From: WILLIFORD Dennis (AREVA) [Dennis.Williford@areva.com]
Sent: Friday, June 28, 2013 7:35 PM
To: Snyder, Amy
Cc: Mitra, Sikhindra; ANDERSON Katherine (EXTERNAL AREVA); DELANO Karen (AREVA); LEIGHLITER John (AREVA); ROMINE Judy (AREVA); RYAN Tom (AREVA); PANNELL George (EXTERNAL AREVA); HOTTLE Nathan (AREVA)
Subject: Response to U.S. EPR Design Certification Application RAI No. 564 (6901), FSAR Ch. 8, Supplement 1
Attachments: RAI 564 Supplement 1 Response US EPR DC.pdf

Request for Additional Information 564, Supplement 1

Application Title: U. S. EPR Standard Design Certification - Docket Number 52-020

Review Section: 08.02 - Offsite Power System

Overview U.S. EPR Offsite Power Supply Design for the EATs

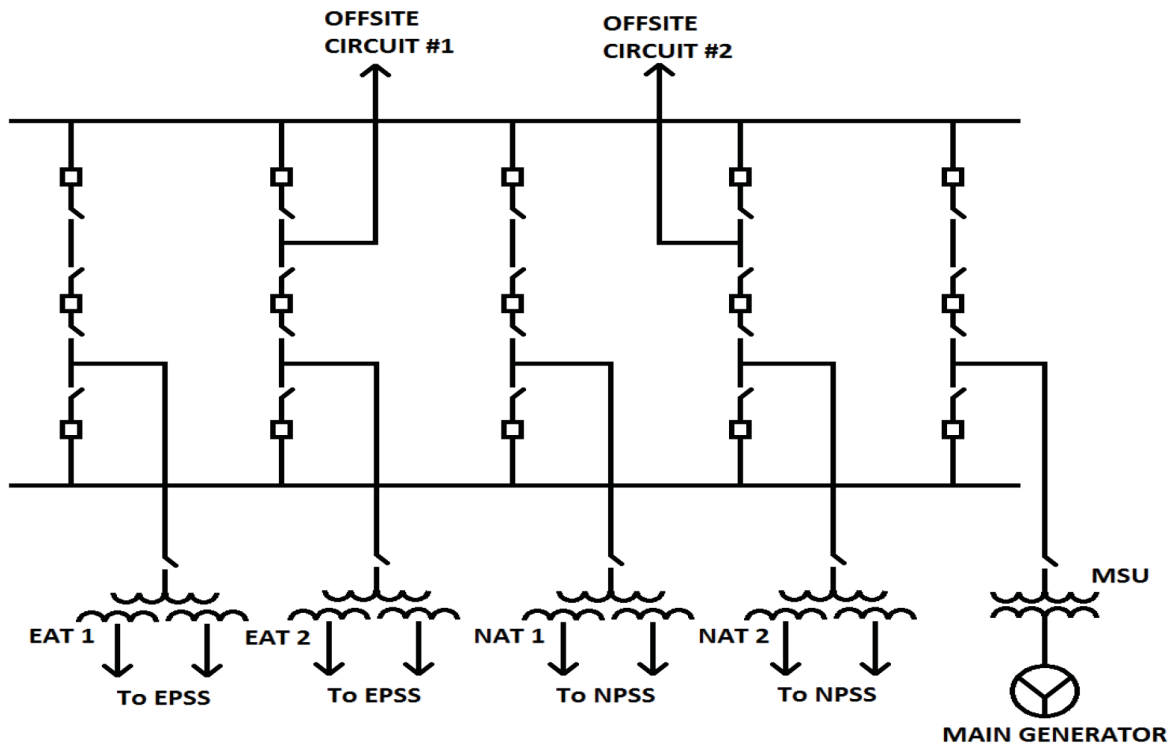
- Describe the protection scheme design for important to safety buses (31-34BDA) to detect and automatically respond to a single-phase open circuit condition or high impedance ground fault condition on credited offsite power circuits.
- If the important to safety buses are not powered by offsite power sources during at power condition, explain how the surveillance tests (e.g., SR 3.8.1.1) are performed to verify that a single-phase open circuit condition or high impedance ground fault condition on an off-site power circuit is detected.
- Describe the plant operating procedures including off-normal operating procedures, specifically calling for verification of the voltages on all three phases of the ESF buses.

The four Class 1E Emergency Power Supply System (EPSS) Buses 31-34BDA of the U.S. EPR design are powered from two, 25 MVA, 3-winding Emergency Auxiliary Transformers (EAT), 30BDT01 and 30BDT02. The three windings of each EAT are connected Wye; the primary, high-voltage side neutral is solidly grounded, and the two secondary, low-voltage side neutrals are each high-impedance grounded. Although each EAT has the capacity and capability to power all four EPSS buses (31-34BDA) under all design basis conditions, the normal operating configuration is for each EAT secondary winding to power a single EPSS bus.

The EATs are powered by dedicated 500KV off-site feeds that are not used for powering normal operation plant loads such as RCPs, Main Feedwater Pumps, etc. The Normal Auxiliary Transformers (NATs) supply the normal operations plant loads and have their own dedicated off-site power feeds. The U.S. EPR electrical system configuration also assures that should a loss of phase occur on one of the off-site feeds, the emergency buses and associated safety equipment powered by the second off-site feed are unaffected.

The U.S. EPR electrical system off-site power supply design provides a stable, dedicated and voltage regulated power source for the Emergency Buses. This configuration presents a somewhat unique relaying design challenge when trying to monitor for loss of a single off-site power supply phase due to the light loading of the EATs during normal at-power operation. This normal

operating configuration maintains the EATs very lightly loaded, roughly estimated at 5 to 8 MVA each.
